# Modification of Minister's Approval

## Section 75W of the *Environmental Planning & Assessment Act 1979*

<b>Concept Approval:</b>	<b>MP 06_0162</b> granted by the Minister for Planning 9 February 2007
<b>For the following:</b>	Concept Plan for the redevelopment of Barangaroo
<b>Applicant:</b>	Infrastructure NSW
<b>Consent Authority:</b>	Minister for Planning
<b>The Land:</b>	Lots 201-204 DP1204948; Lot 208 DP1211553; Lot 101 DP1204946; Lots CP & 1-159/SP91649; Lot 211 DP1217691; Lot 213 DP 1221076; Lot 301-306 DP 1224221; Lot 401-404 DP 1244222; Lot 500-501 DP 1264241; part of C.T. Volume 5018 Folio 1.
<b>Modification:</b>	<b>MP 06_0162 MOD 11:</b> the modification includes: <ul style="list-style-type: none"><li>• the construction of Hickson Park in seven stages</li><li>• allow non-construction vehicles to also use the temporary road (Barton Street).</li></ul>

**End of Modification  
(MP 06\_0162 MOD 11)**

#### **Appendix 1**

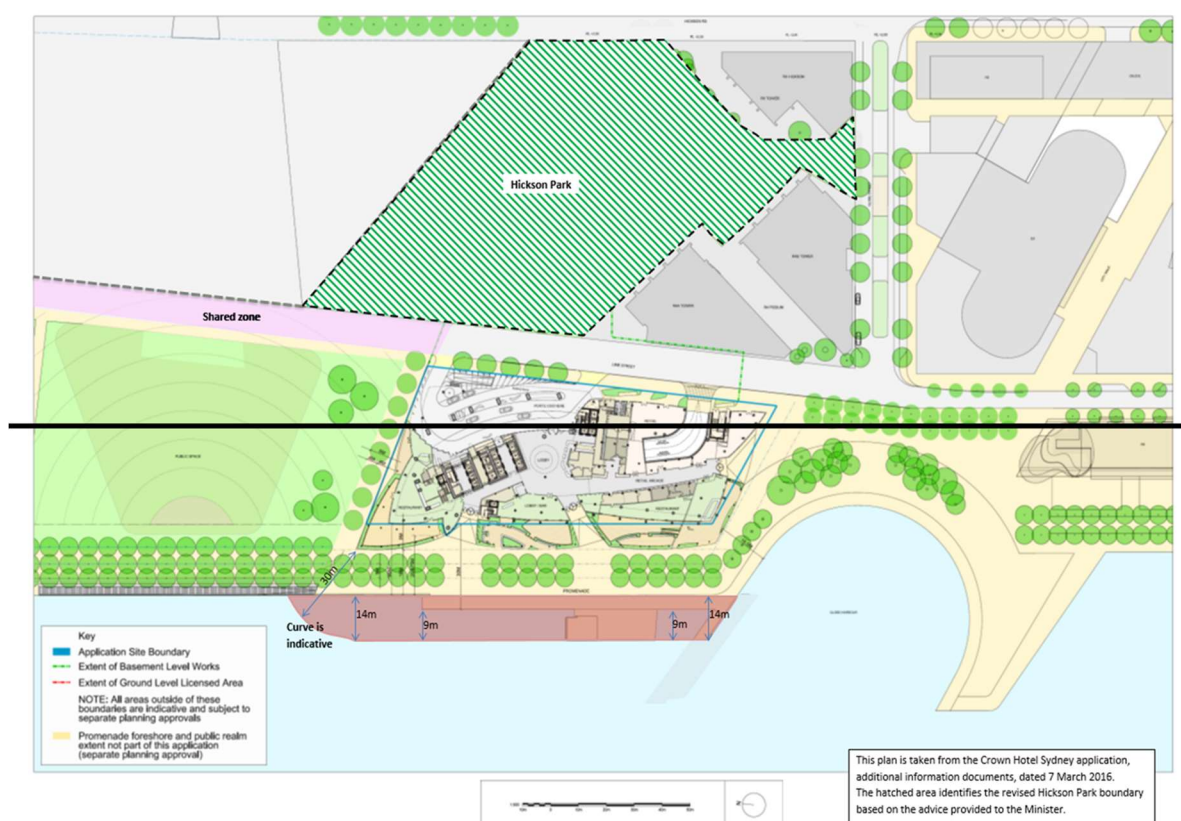
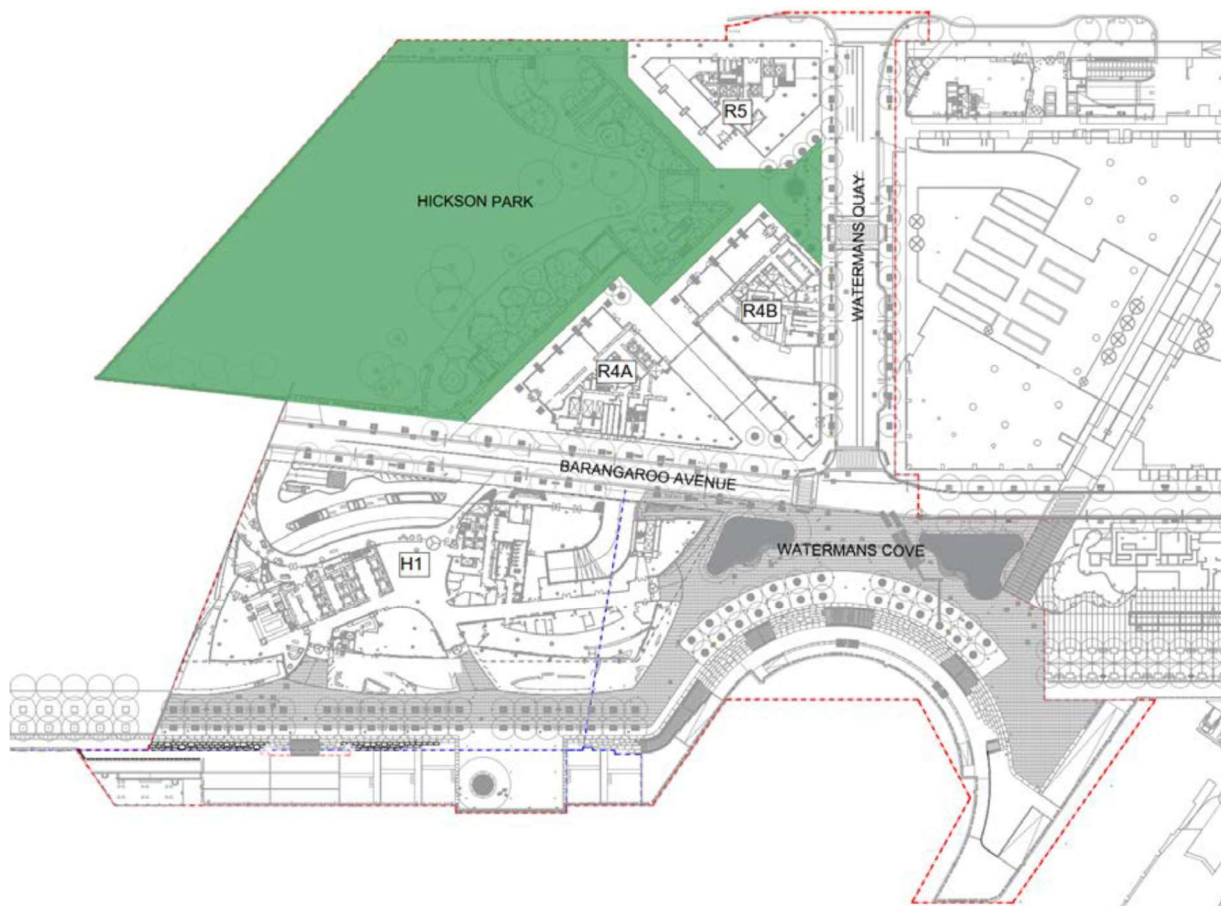
- (g) Appendix 1 is amended by the deletion of the existing plan and insertion of a new plan as follows:
